ATS & PFSP YANG maintenance items #0392 & #0393 ver 2.0

Maintenance items

- [#0392](#)

- [#0393](#)

Figure 48-16—Asynchronous Traffic Shaping model

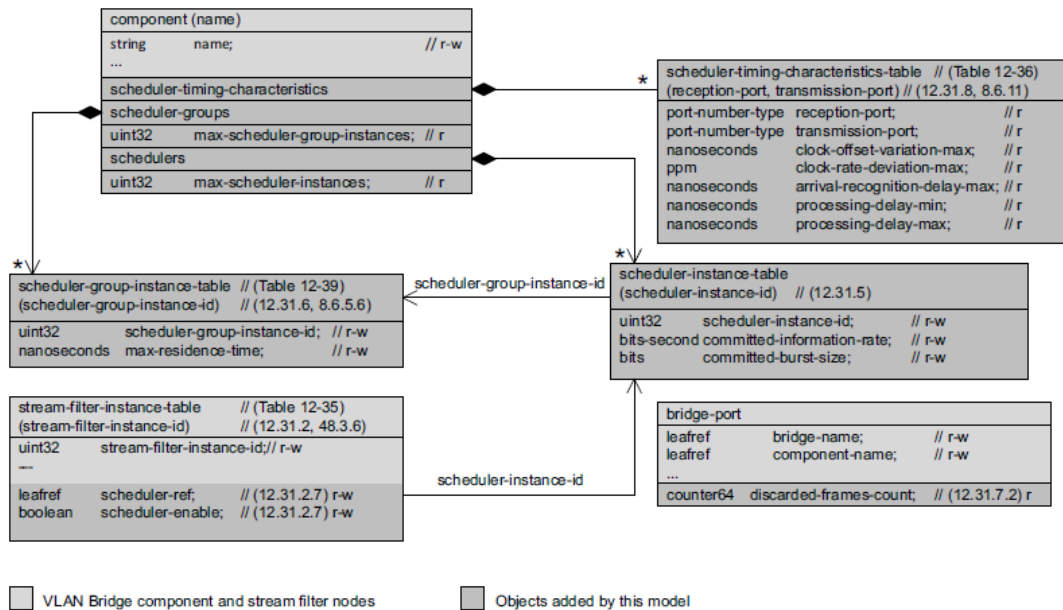
- **ieee802-dot1q-ats-bridge.yang Revision 2023-07-03 doesn't align with following statements**
 - **12.31.5 The Scheduler Instance Table**
 - **There is one Scheduler Instance Table per Bridge Component.** Each table row in the Scheduler Instance Table comprises a set of parameters that defines a single ATS scheduler instance, as detailed in Table 12-38.
 - **12.31.6 The Scheduler Group Instance Table**
 - **There is one Scheduler Group Instance Table per Bridge Component.** Each table row in the Scheduler Group Instance Table comprises a set of parameters that defines a single ATS scheduler group instance (8.6.5.6), as detailed in Table 12-39.

- **Current ieee802-dot1q-ats-bridge.yang**
 - ats:ats-parameters is under augment of “stream-filters/stream-filter-instance-table”
 - It creates multiple *the Scheduler Instance Table (12.31.5)* and *the Scheduler Group Instance Table (12.31.6)* under *the Stream Filter Instance Table (12.31.2)* than one per the Bridge Component.

- No change needed on `ieee802-dot1q-ats.yang`
- Modified `ieee802-dot1q-ats-bridge.yang`
 - Move `ats:ats-parameters` out of augment of “stream-filters/stream-filter-instance-table”
 - It creates *single Scheduler Instance Table (12.31.5)* and *single Scheduler Group Instance Table (12.31.6)* under the Bridge Component.

Figure 8-15—Per-stream classification and metering for ATS

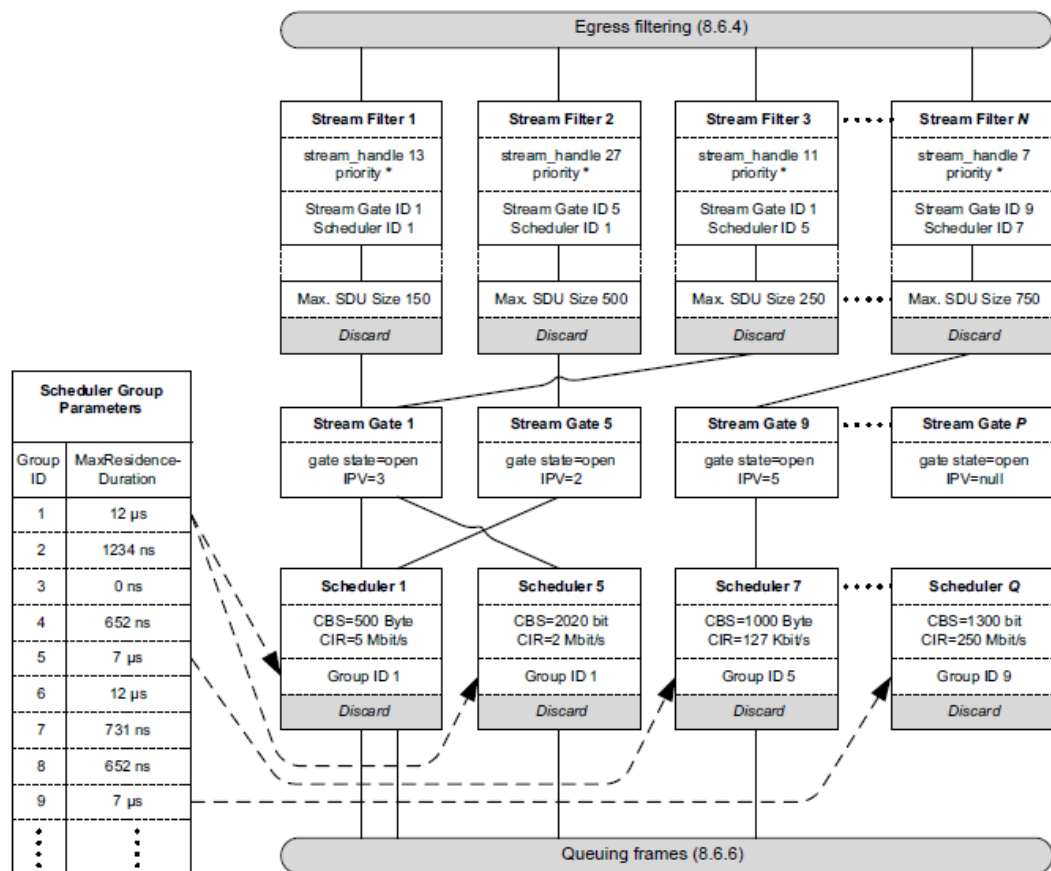
Each Bridge component that implements *ATS* shall support *stream filtering*, *maximum SDU size filtering*, *stream gates supporting IPV assignment*, *ATS schedulers*, and *ATS scheduler groups*, with the following:

- A single *Stream Filter Instance Table* (8.6.5.3).
- A single *Stream Gate Instance Table* (8.6.5.4). If the Bridge component does not support PSFP in addition to ATS, each stream gate only supports IPV assignment (8.6.5.4). IPV can be used as part of adjusting per-hop delay bounds to meet specific networks' end-to-end delay requirements.
- A single *ATS Scheduler Instance Table* (8.6.5.6).
- A single *ATS Scheduler Group Instance Table* (8.6.5.6).
- An *ATS Port Parameter Table* for each Bridge Port (8.6.5.6).

Figure 8-13—Flow classification and metering

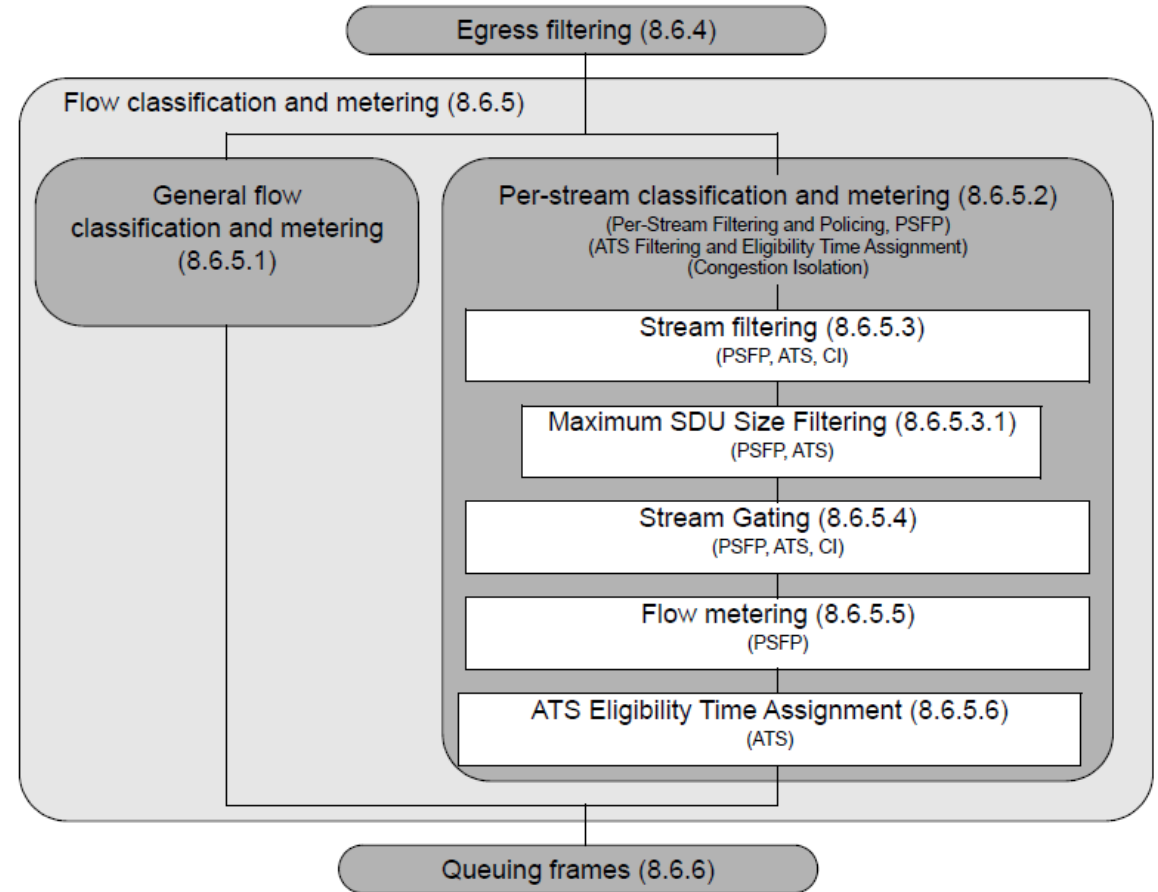
- **8.6.5 states**
 - “PSFP and ATS share common per-stream classification and metering elements, as shown in Figure 8-13.”
- **8.6.5.2 d) states**
 - “... A given stream filter can be configured with flow meters and an ATS scheduler if both PSFP and ATS are supported.”
- **8.6.5.2.2 b) states**
 - “If the Bridge component does not support PSFP in addition to ATS, each stream gate only supports IPV assignment. ...”
 - NOTE 2—For bridges with support for ATS, and without support for PSFP, stream gates of ATS traffic will never close. In this case, stream gates are only used for IPV assignment.

- Create container of *stream-gates* and *stream-filters* under “/dot1q:bridges/dot1q:bridge/dot1q:component” instead of “grouping” & “uses” statement for Stream Filter and Stream Gate
- Those are created as “*sfsg-bridge-new:stream-gates*” and “*sfsg-bridge-new:stream-filters*”
- Share them with other modules of ATS, PSFP and CI.
- Additional containers can be augmented by each module.
